**SUBJECT: REVISION "C" TO TECHNICAL BULLETIN 212-88-105:
TAILBOOM ASSEMBLIES, P/N 212-030-100-005 / -049 / -057 / -
063 / -069 / -097 / -103 / -115 / -121 / -133 / -147 / -159 / -177 / -
191 and -203, MODIFICATION FOR USE ON ALL MODEL 212
HELICOPTERS**

No. 212-88-105

REV C

MODEL AFFECTED: 212

Figure 1 (Sheet 1 of 2)
 2-way stop installation

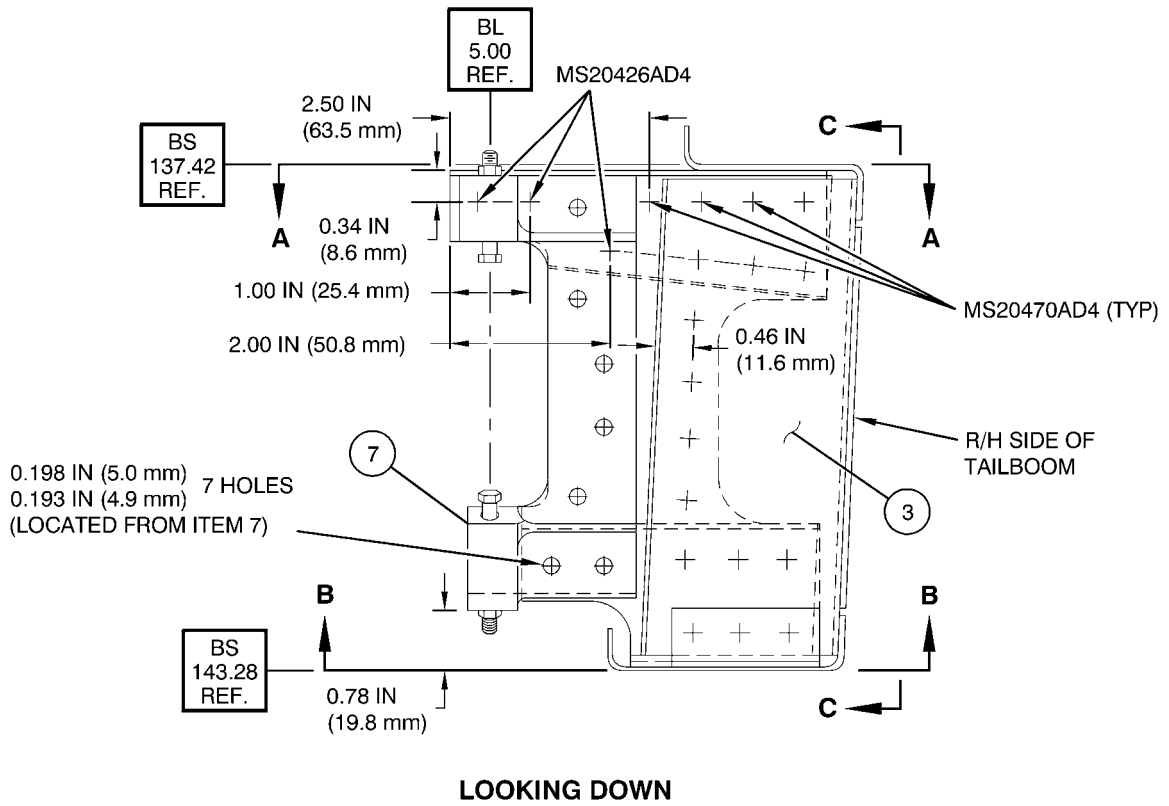
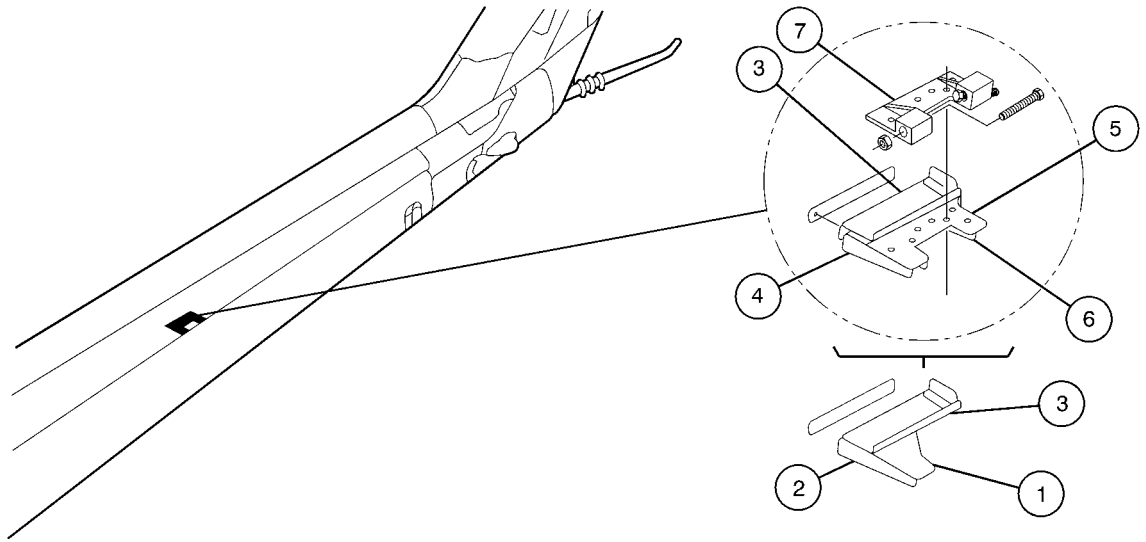
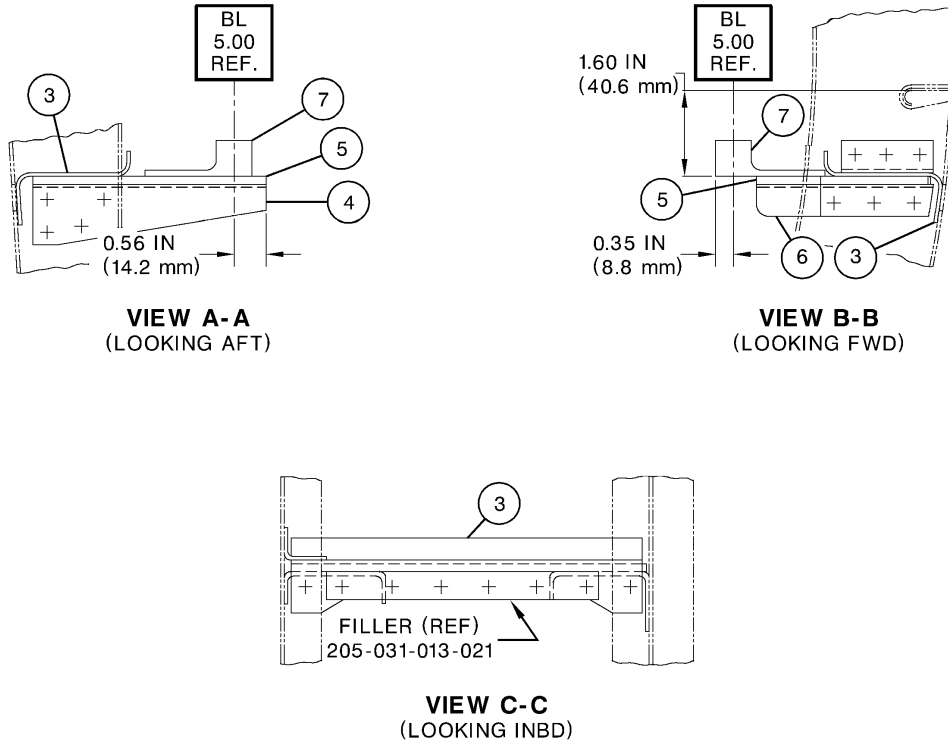
2. Replace elevator horn stop, if required per Table 1, using the following procedure and referring to Figure 1 & 2:
 - a. Move elevator horn away from work area (or remove horn assembly) to gain access to stop. Refer to maintenance manual, Chapter 67 for removal.
 - b. Remove existing stop (1), clip (2) and support (3).
 - c. Install new support (3), support (4), stop (5) and support (6), locate as shown on Figure 1. Maintain an edge distance of 2D for all brazier-head rivets and 2.5D for all countersunk rivets. Refer to BHT-MED-SRM-1 for rivet installation.

- d. Drill (Qty 7) holes in stop assy. (7) as per Figure 2.
 - e. Locate stop assy. (7), transfer holes to stop (5), support (6) and support (4).
 - f. Move elevator horn back to position (or reinstall). Refer to maintenance manual for reinstallation of elevator horn. Install stop assy. as per Figure 1 with screws P/N MS27039-1-11, washers P/N NAS1149D0332J and nuts P/N MS21042L3.

- | REMOVE: | INSTALL: |

| 1. 205-031-013-019 | 3. 205-031-013-023 |
| 2. 205-031-013-015 | 4. 205-031-013-139 |
| 3. 205-031-013-023 | 5. 205-031-013-137 |
| | 6. 205-031-013-121 |
| | 7. 412-030-103-109 |

Figure 3
Installation of stiffener

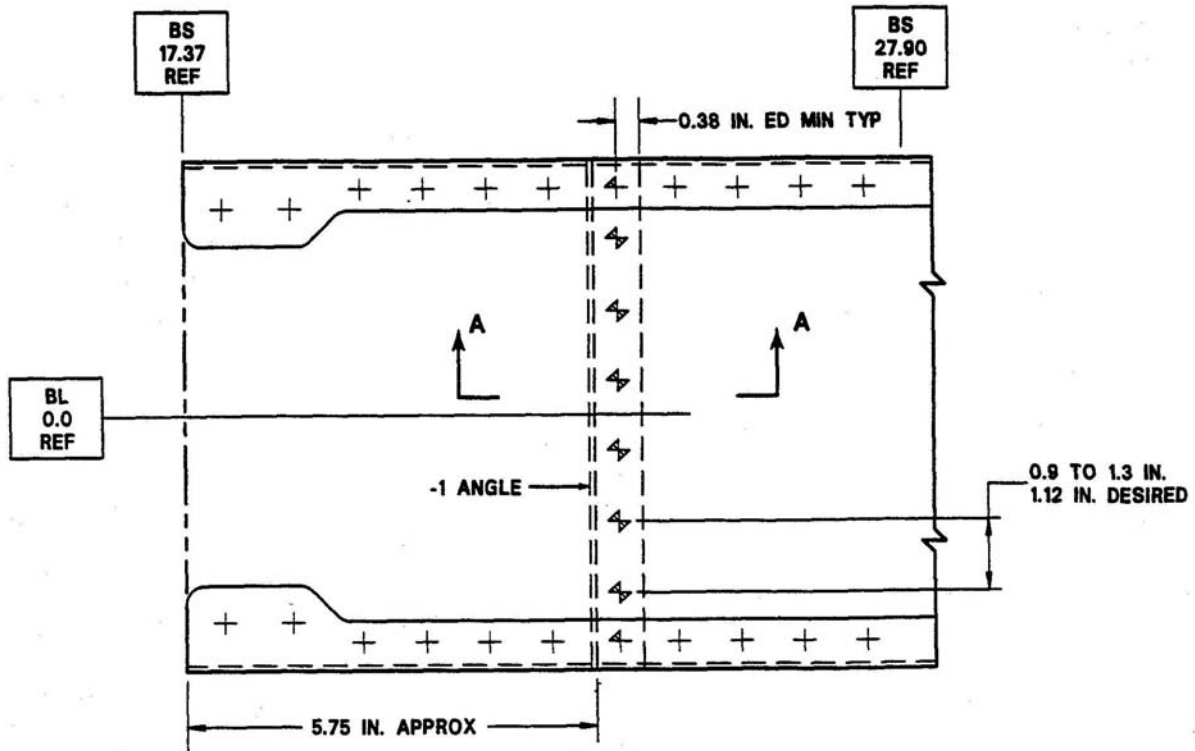
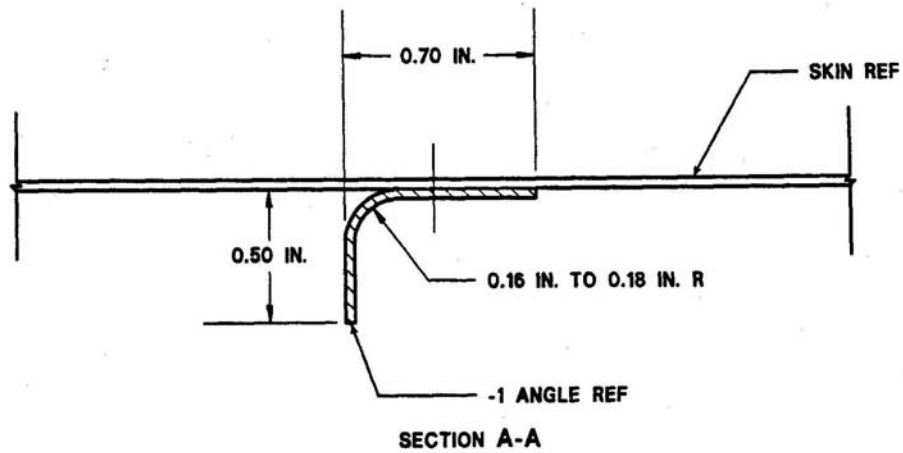
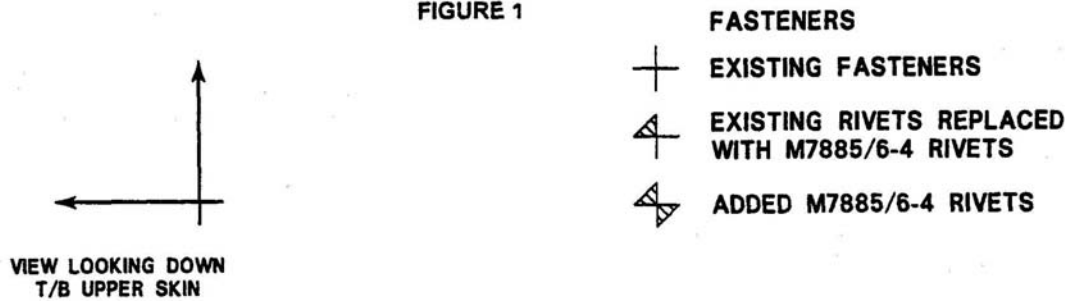
3. Install the top skin stiffener, if required per Table 1, using the following procedure and referring to Figure 3.
- a. Gain access to modification area by removing inspection panel in forward section of baggage compartment roof panel.

- b. Open forward drive shaft cover and remove tail rotor drive shaft section above modification area as per BHT-212-MM, Chapter 65.
 - c. Layout position of -1 stiffener angle to be installed on tailboom top skin as per dimensions noted on Figure 3.

- d. Remove (Qty 2) existing fasteners attaching L/H & R/H drive shaft cover angles to tailboom top skin.
 - e. Fabricate -1 stiffener angle from P/N 150-021-14C1-1 repair sheet dimensionally as per Figure 1 and section A-A. Alternate material 2024-T3 0.040" Al Alloy per QQ-A-250/4 may be used.

- f. Fabricate a template to transfer the two (2) existing fastener locations of step 3d with # 27 drill to template. Note the L/H - R/H orientation on template. Cleco template in position using the two existing fastener locations drilled in template. Lay out and drill six (6) # 40 pilot holes through template and tailboom top skin for the remaining holes, using pattern shown on Figure 1. Maintain proper edge distance and spacing.

- g. Use template to transfer the existing fasteners locations of step 3d with # 27 drill and the six (6) # 40 pilot holes into -1 stiffener angle. Note the L/H - R/H orientation and that the angle flange of the -1 stiffener angle is to be installed forward as per Figure 3. Maintain proper edge distance and spacing.

- h. Open # 40 pilot holes in -1 stiffener angle and tailboom top skin to fastener hole size with # 27 drill.
 - i. Deburr all holes; remove debris and loose material. Clean and prime -1 stiffener angle with epoxy polyamide primer MIL-P-85582, TY1, CL2 and allow to dry.

- j. Apply a thin coat of sealant P/N MILS81733TY II-2 4OZ to faying surface of -1 stiffener angle.
- k. Locate -1 stiffener angle in position on underside of tailboom top skin using lockwire. This is done by routing two (2) strands of lockwire down through two separate holes previously drilled in the tailboom top skin and out through the access panel hole. Attach the lock-wire to the same hole locations in the -1 stiffener angle in a manner that when the -1 stiffener angle is pulled up into position the wire can be released or pushed back through access panel opening, to facilitate removal of the lock-wire. Note that the -1 stiffener angle flange is to be installed forward as per Figure 1. Use clecos to hold in position. Secure using fasteners specified in Figure 3 with wet sealant P/N MILS81733TY II-2 4OZ
